TECHNICAL NOTE

HUYTON TRADE PARK

RESPONSE TO KMBC

Client/Project owner	Derwent Development Management Limited
Project	Huyton Trade Park
Title of Document	Response to KMBC
Type of Document	Technical Note
Date	22/02/2023
Reference number	GB01T20E53.2PROJ.11020624
Number of pages	8

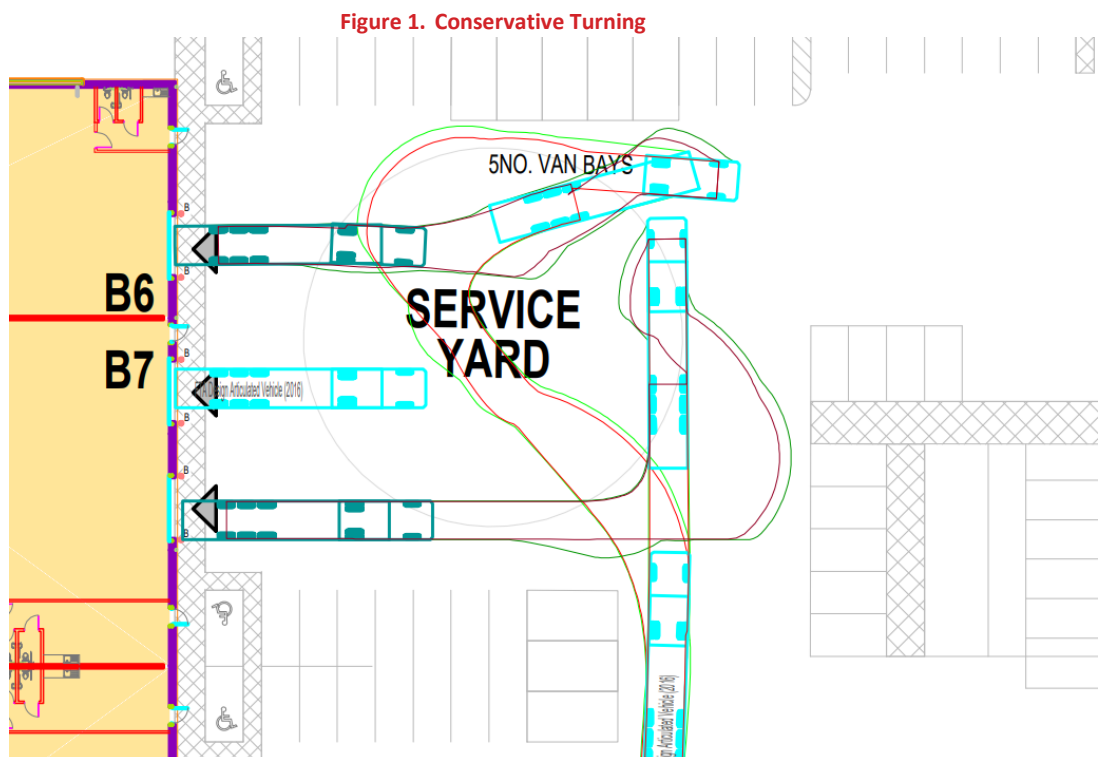
HGVs will likely require access to the B8 units within the site and it is noted that swept paths have been supplied showing this. However, new swept paths which show a more conservative turning circle are required. This is particularly relevant for the Swept Path Analysis Option 2 on Sheet 1 (Drawing No. 20E53-SK-SPA-01). These swept paths show HGVs reversing for approximately 50 metres and encroaching upon yard space which may not be always available during the day (or in use by the neighbouring unit to the west).

A more conservative swept path will be required to show that HGVs can turn when space within the development is limited by other vehicles.

- 2.1.2 A further swept path analysis has been undertaken to reflect a more conservative turning manoeuvre which can be achieved safely within the site when considering other vehicles [Drawing no. 20E53-SK-SPA-13]. The conservative manoeuvre clearly requires less space within the service yard, yet continues to demonstrate its achievability without encroachment into other parking spaces or conflicting with other parked vehicles. An extract of this is presented in **Figure 1** for reference.

Figure 2. Eastern approach

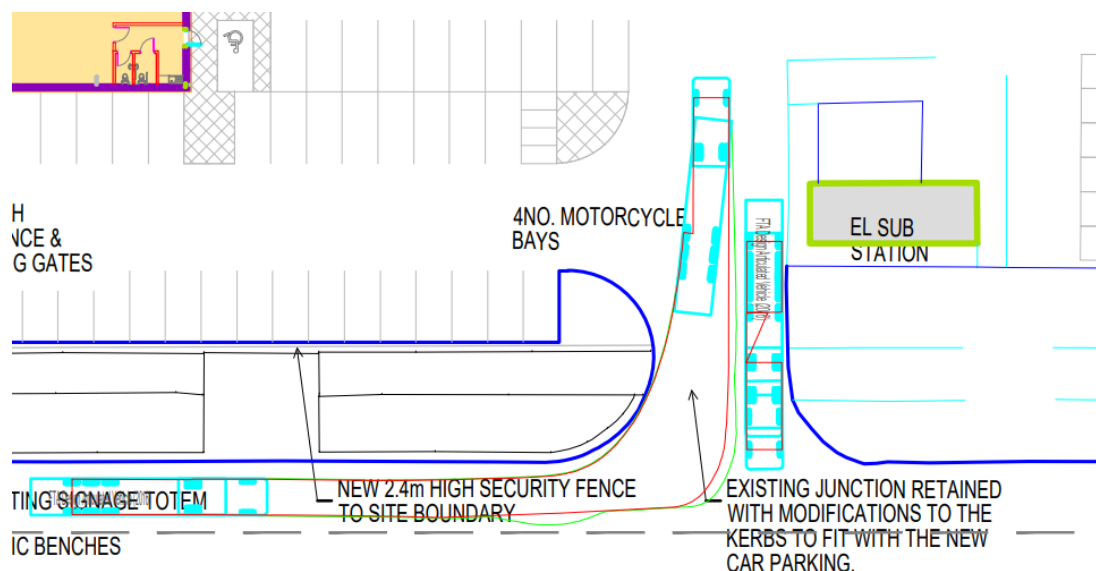
Swept paths will also be required to show that an HGV can turn into the site whilst another HGV is waiting to exit from the western access point.

This is to assess the suitability of the B8 access. If the access is found to not be suitable (i.e. encroaching on footway, overlapping other swept paths), then mitigation will be required. This could include increased radii on access.

- 2.1.3 Drawing Nos. 20E53-SK-SPA-11 and 20E53-SK-SPA-12 demonstrate sufficient space for a maximum legal HGV to access the application site via the existing western access whilst a similar HGV is waiting to exit; it is clear, therefore, that there is sufficient space for a HGV to access from Wilson Road when approaching from both the west and east. **Figure 2** is an extract of Drawing no. 20E53-SK-SPA-11 and presents the movement for a vehicle approaching from the east. We would also note that the requirement for HGV access is pre-existing, the access into an operational employment site already exists within an operational industrial/business park. We would also note that the form of access is typical of those seen elsewhere within the estate.

Figure 3. Exiting to the west

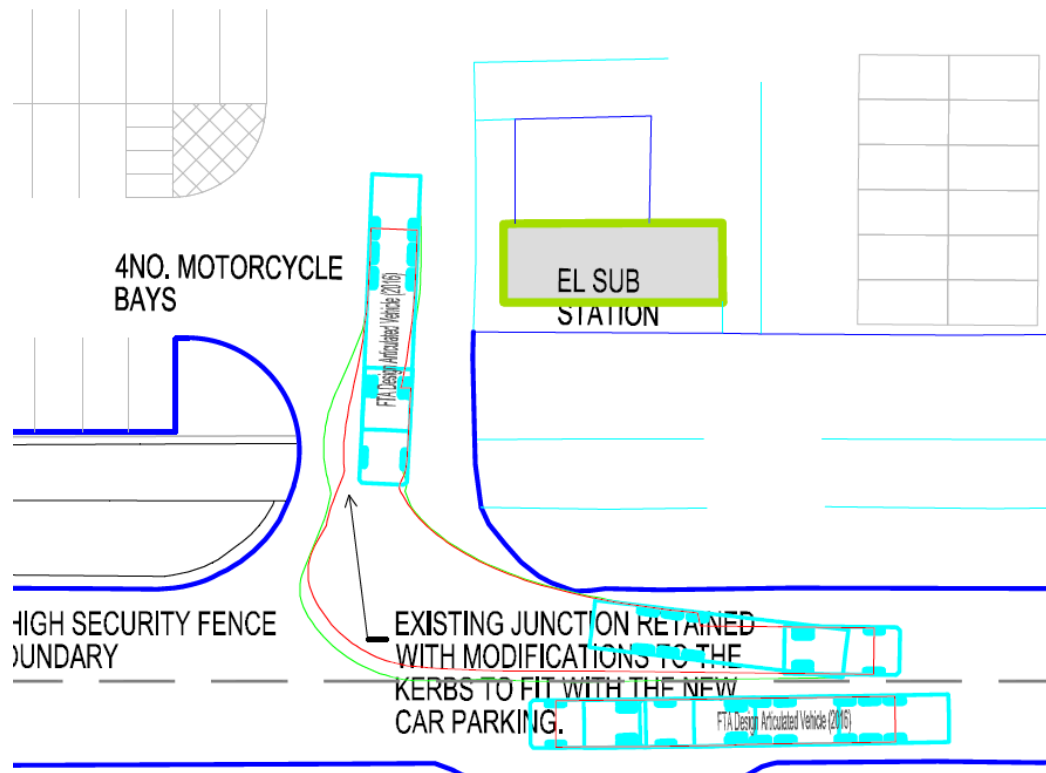
*Existing swept paths show some vehicles to be occupying the right-hand lane which is deemed unacceptable by KMBC. **Any swept paths showing the incorrect side of the carriageway being utilised will not be accepted.***

- 2.1.4 The additional swept path analysis shows a maximum legal HGV exiting the application site and routing to the west [Drawing no. 20E53-SK-SPA-14] via Wilson Road. As shown, HGV drivers are able to undertake this manoeuvre without crossing the centre line of Wilson Road [Figure 3].

- 2.1.5 We appreciate, however, that a similar vehicle would be unlikely to turn right into the development at the same time. However, as set out in the in the Operational Management Plan [OMP] (accompanying the planning application) the forecast number of HGV trips is very low in any one hour period; consequently, the likelihood of this situation occurring is also very low.

Drawn	MB	Checked	JB	Approved	TD
Original dtp. size	A3	Date	20.02.23	Scale	NTS
Drawing Status	INFORMATION		Drawing Number	20E53-SK-SPA-11	Rev. P01

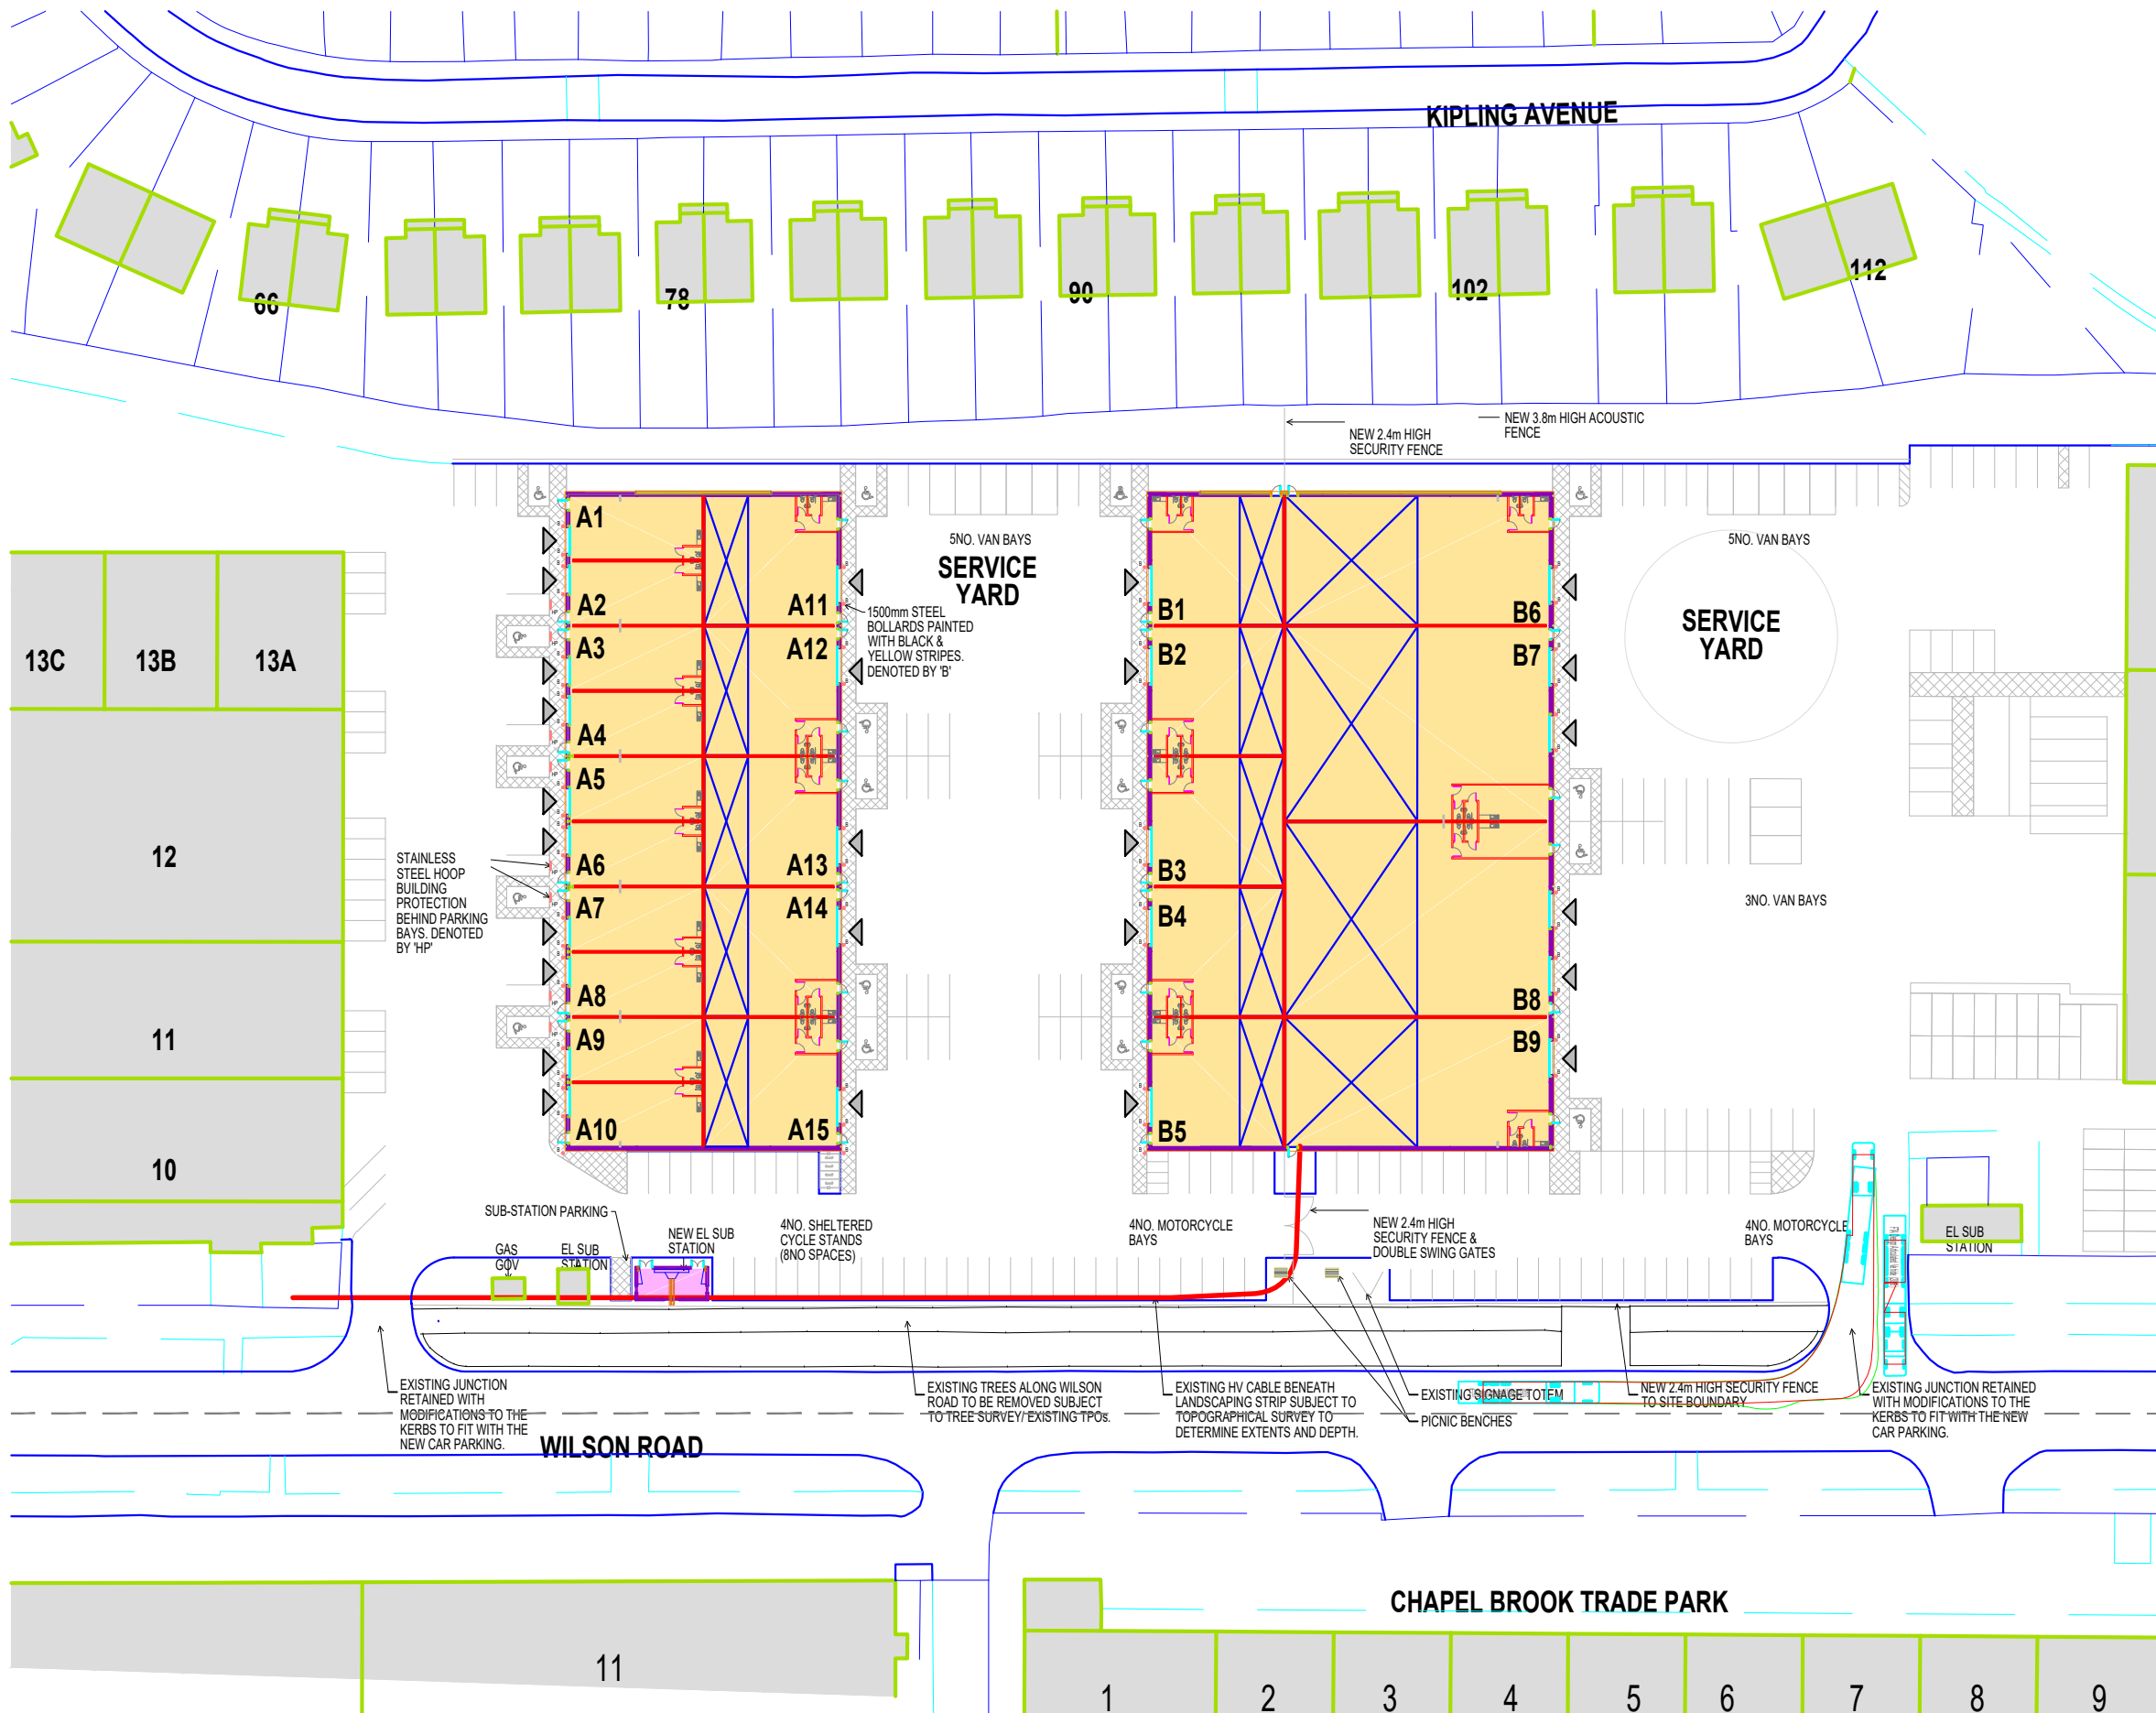
Swept paths will also be required to show that an HGV can turn into the site whilst another HGV is waiting to exit from the western access point. This is to assess the suitability of the B8 access. If the access is found to not be suitable (i.e encroaching on footway, overlapping other swept paths), then mitigation will be required. This could include increased radii on access.

Drawn	Checked	Approved
MB	JB	TD
Original dtp. size	Date	Scale
A3	20.02.23	NTS
Drawing Status	Drawing Number	Rev.
INFORMATION	20E53-SK-SPA-13	P01

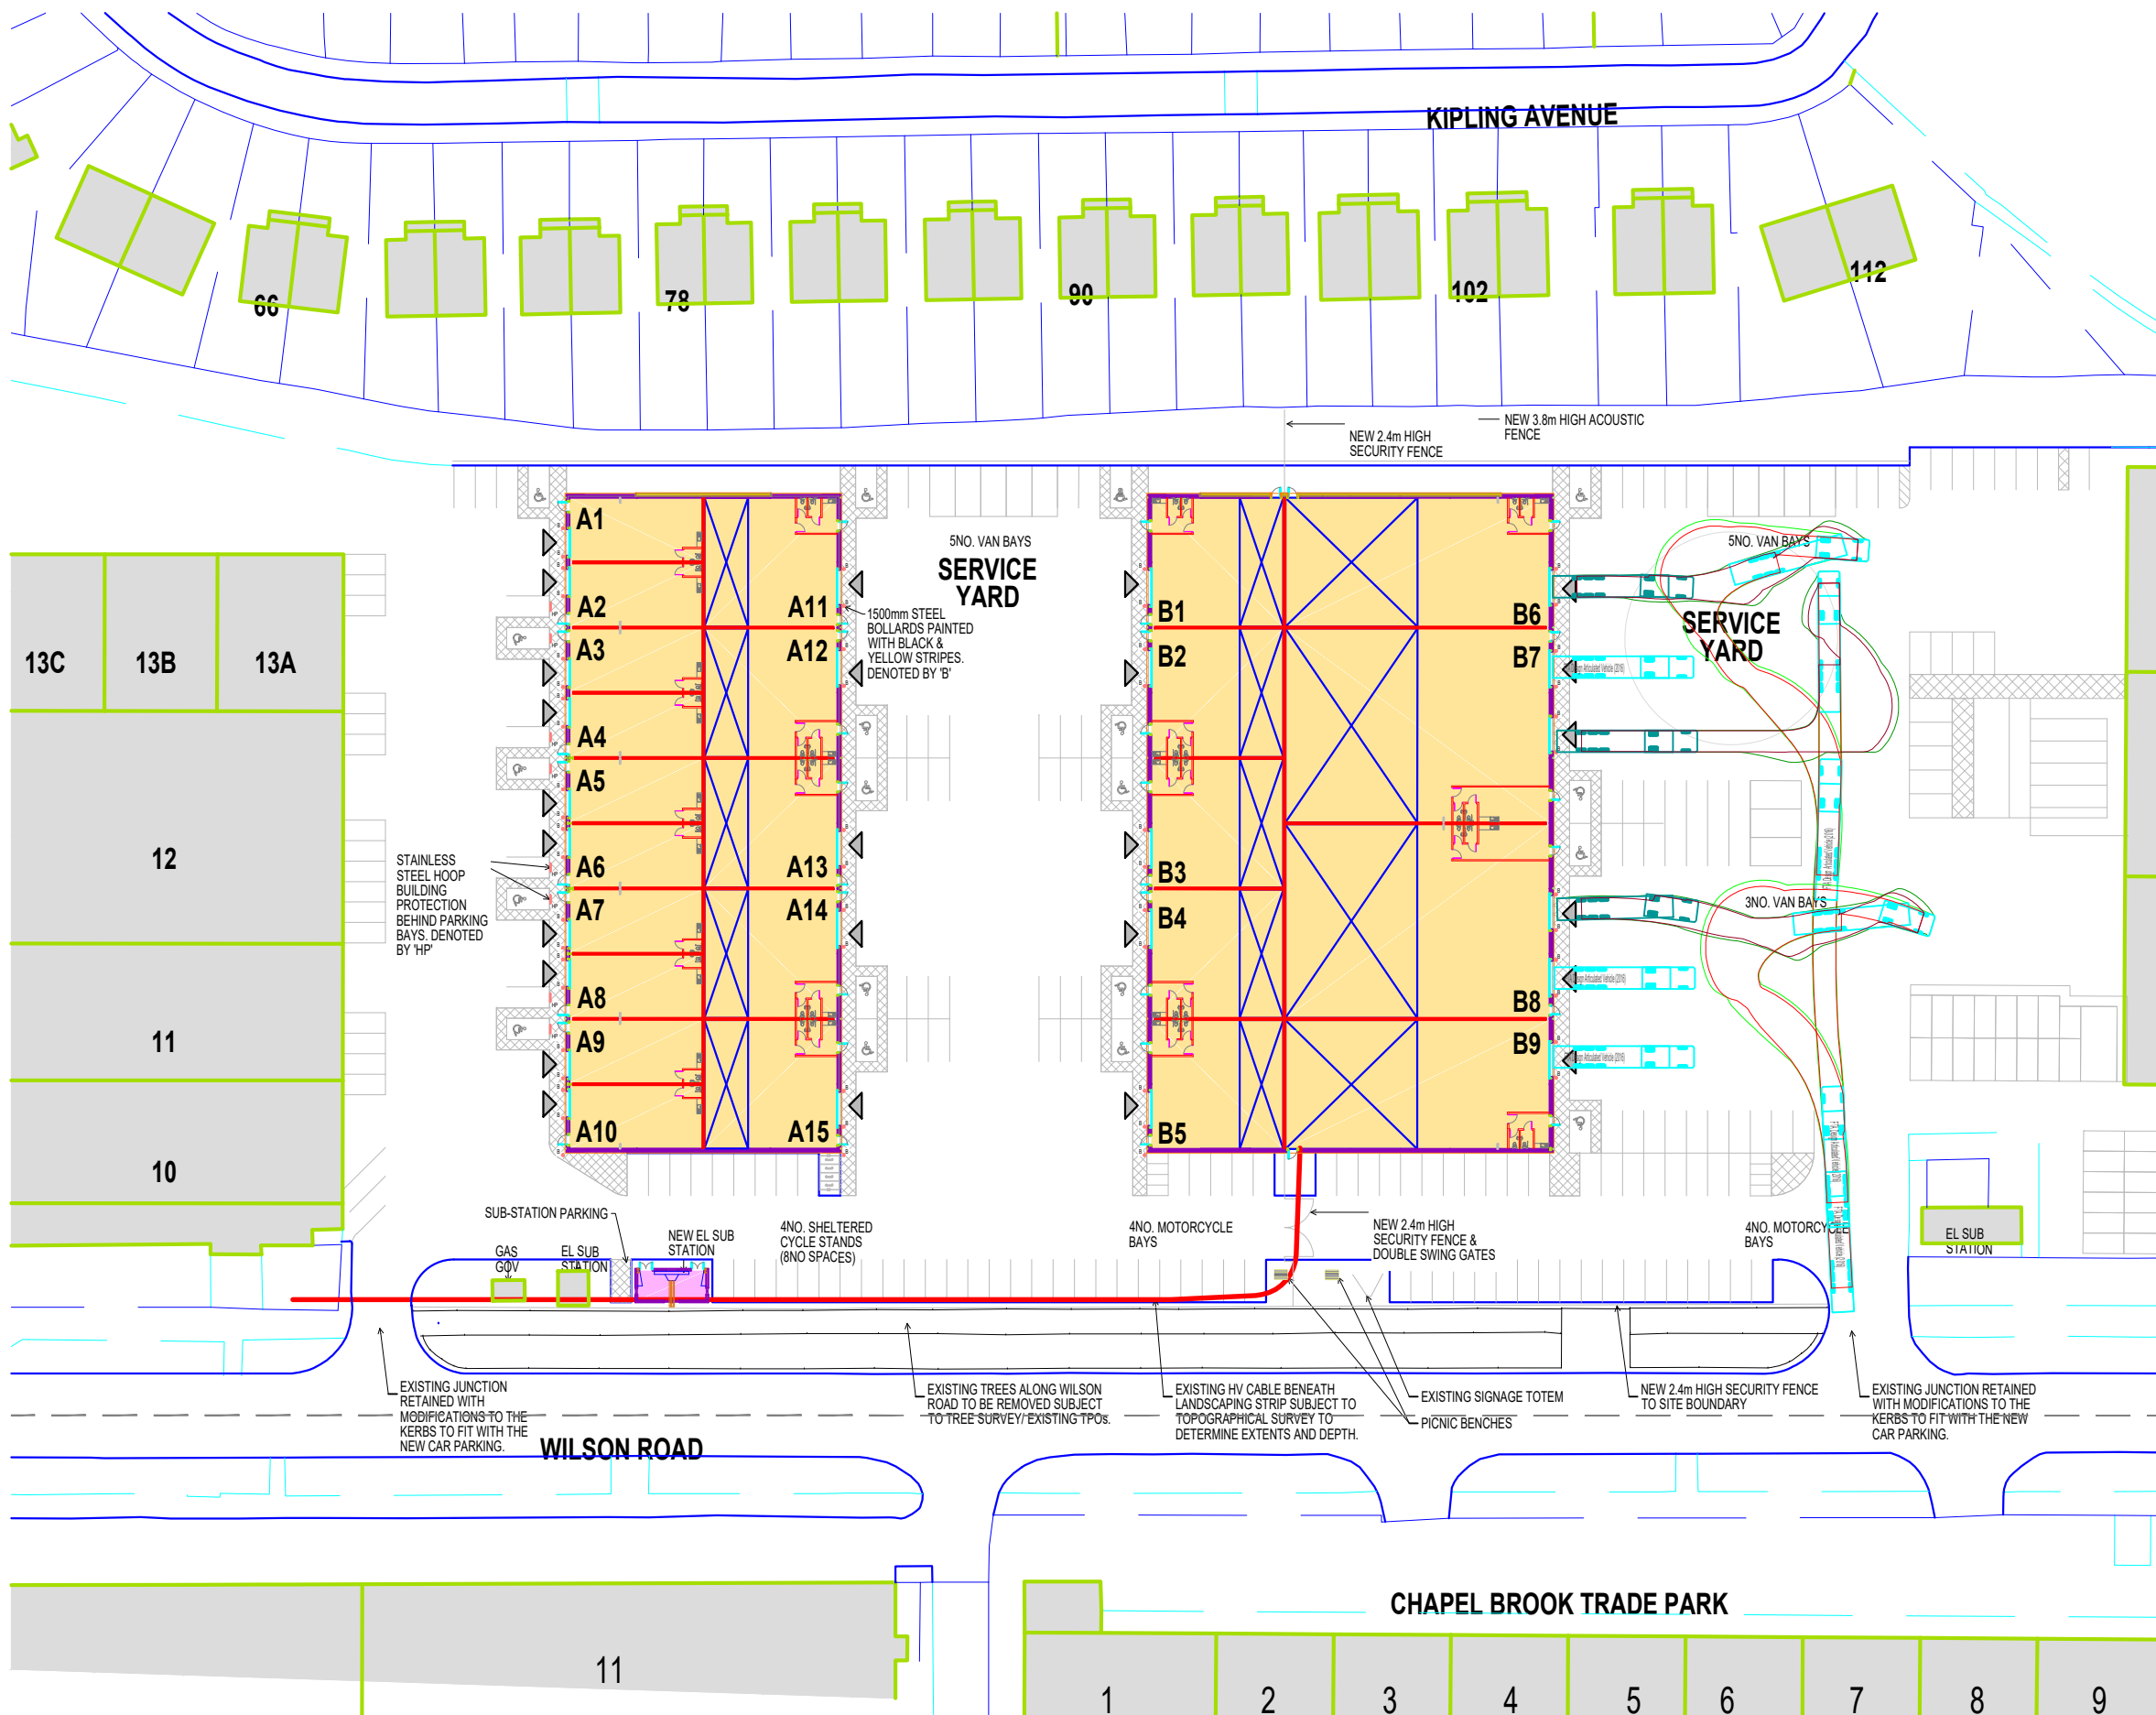
HGVs will likely require access to the B8 units within the site and it is noted that swept paths have been supplied showing this. However, new swept paths which show a more conservative turning

circle are required. This is particularly relevant for the Swept Path Analysis Option 2 on Sheet 1 (Drawing No. 20E53-SK-SPA-01). These swept paths show HGVs reversing for approximately 50 metres and encroaching upon yard space which may not be always available during the day (or in use by the neighbouring unit to the west). A more conservative swept path will be required to show that HGVs can turn when space within the development is limited by other vehicles.
